L-2012-296  
10 CFR 52.3

Re: Florida Power & Light Company  
Proposed Turkey Point Units 6 and 7  
Docket Nos. 52-040 and 52-041  
Response to NRC Request for Additional Information Letter 120329  
(eRAI 6354 Rev. 0) Related to ESRP Section 2.3.1 - Hydrology

Attachment 1: FPL Response to NRC RAI EIS 2.3.1-2 (eRAI 6354 Rev. 0)

Attachment 2: FPL Response to NRC RAI EIS 2.3.1-6 (eRAI 6354 Rev. 0)

**Figure 1**  
**Extended Power Uprate Monitoring Well Locations**

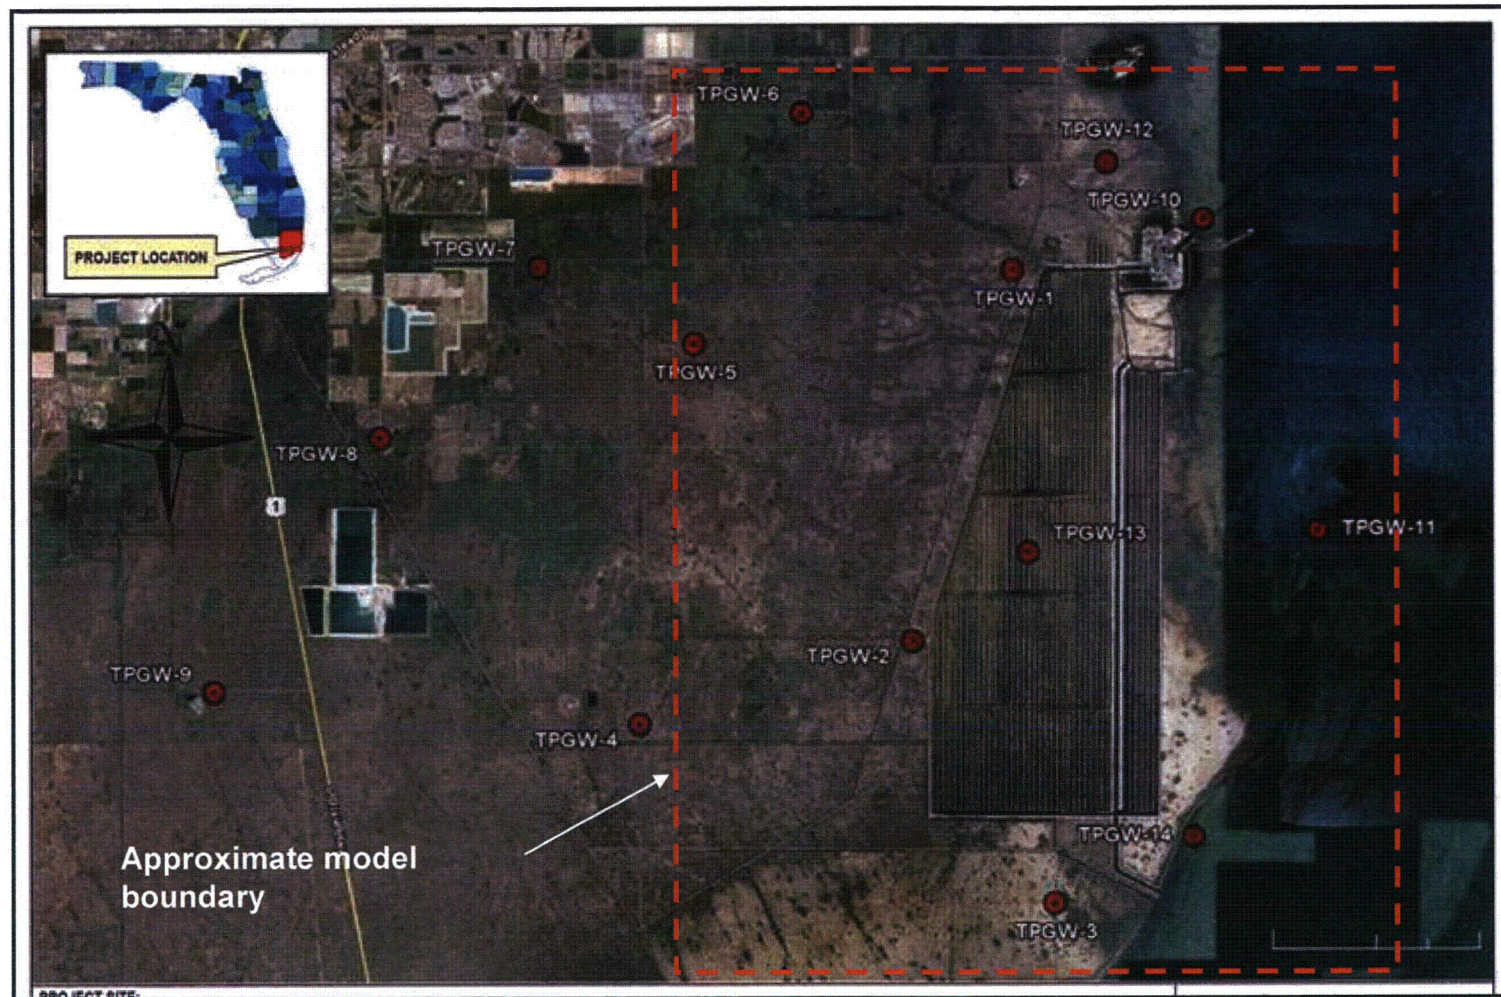
Sampling errors result from the inadequate density, frequency, and duration of measurements used to characterize the environment. The density, frequency, and duration of measurements have been provided either indirectly or directly in the applicant's environmental report and security control assessor information. However, the applicant has not discussed the basis for their implicit assumption that potential sampling errors are not a plausible basis that might change the impact determination. The review team requests that the applicant discuss the basis for this assumption.

The EPU borings, as shown in Figure 1 and designated as TPGW wells (JLA Geosciences, Inc., 2010), were utilized for comparison with the model hydrostratigraphy. Stratigraphic data

from these wells improved the offsite subsurface dataset and were used in the Turkey Point Units 6 & 7 groundwater flow model to qualitatively assess the thickness and extent of layers used in the model. Specifically, the thickness and extent of the Upper and Lower Higher Flow Zones were identified in these borings and compared to the conceptual model hydrostratigraphy, which was already incorporated into the model. The results of this comparison showed agreement between the conceptual model and the newer boring information. This comparison suggests that the boring density used in the conceptual model was sufficient to adequately characterize the subsurface conditions.

**Figure 1. General-Head Boundaries along Model Perimeter**

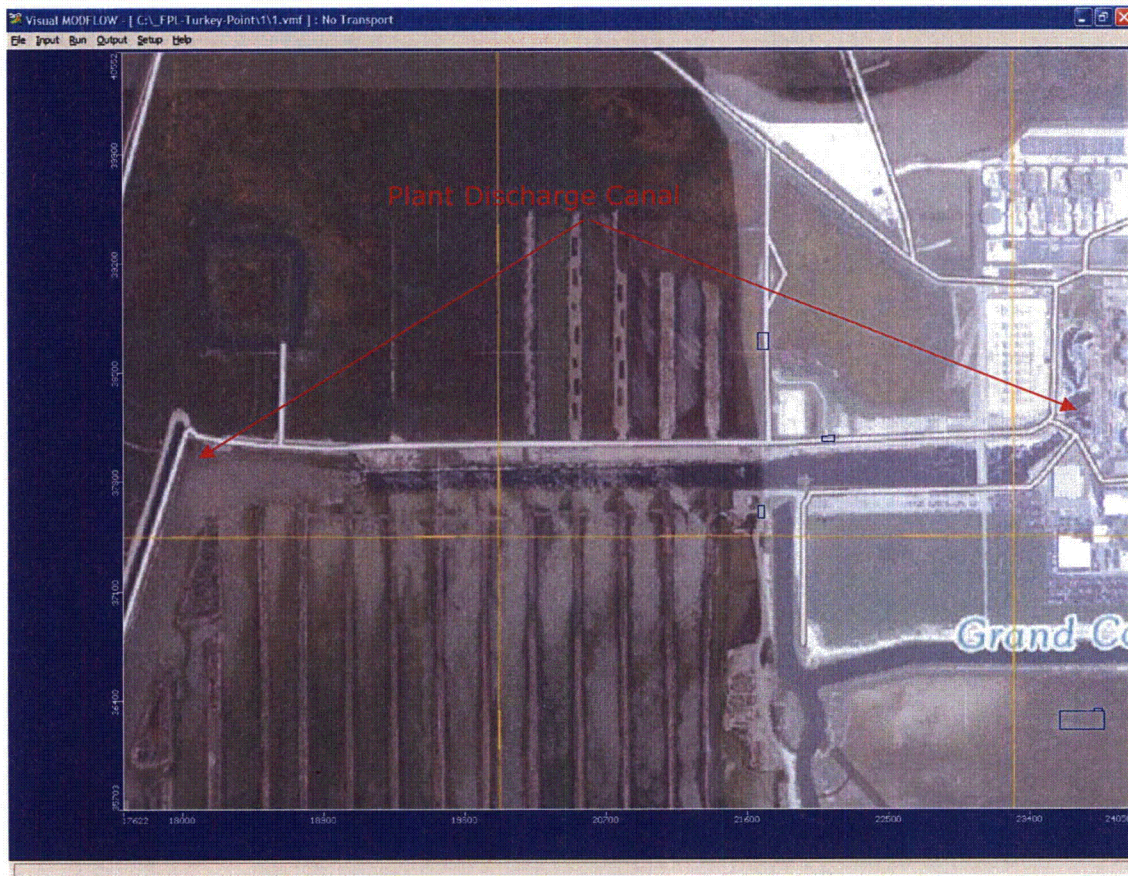
- a. the perimeter boundaries defined as "general head boundaries"
- b. the "river package" boundary between Plant Discharge Canal and the Upper High Flow Zone (Model Layer 4)
- c. the "river package" boundary representing the regional canals and the Interceptor Ditch
- d. the general head boundary at the bottom of Biscayne Bay for each of the materials defined at this boundary (i.e., sandy sediment and rock)

Model perimeter boundaries are shown in Figure 1. The cell width along the model perimeter is small relative to the model area, so the boundary cells appear as a narrow green-shaded band in Figure 1 around the model perimeter. The general-head boundary (GHB) package was used to simulate groundwater flow into and out of all sides of the model domain and for all model layers. The rationale for using this boundary package is that with the exception of Biscayne Bay, no water bodies representing fixed-water elevations exist. The benefit of using the GHB package for perimeter boundaries is that it permits extending boundary conditions outside of the numerical grid rather than expanding the numerical grid to coincide with natural boundaries.

The perimeter boundary distances (D) are assigned as follows (see Figure 1):

- Western boundary:  $D = 52,766$  ft (western extent of available water level data)
- Eastern boundary:  $D = 2500$  ft (along Biscayne Bay)
- Northern boundary: The Biscayne Bay coastline along this boundary is located at model grid x-coordinate of 21,500 ft. For cells inland of Biscayne Bay,  $D = 18,948 \text{ ft} - X_i \times [(18,948 \text{ ft} - 2500 \text{ ft}) / 21,500 \text{ ft}]$ , where  $X_i$  is cell center coordinate in x-direction. For Biscayne Bay cells,  $D = 2500$  ft.
- Southern boundary: The Biscayne Bay coastline along this boundary is located at model grid x-coordinate of 20,320 ft. For cells inland of Biscayne Bay,  $D = 12,512 \text{ ft} - X_i \times [(12,512 \text{ ft} - 2500 \text{ ft}) / 20,320 \text{ ft}]$ , where  $X_i$  is cell center coordinate in x-direction. For Biscayne Bay cells,  $D = 2500$  ft.
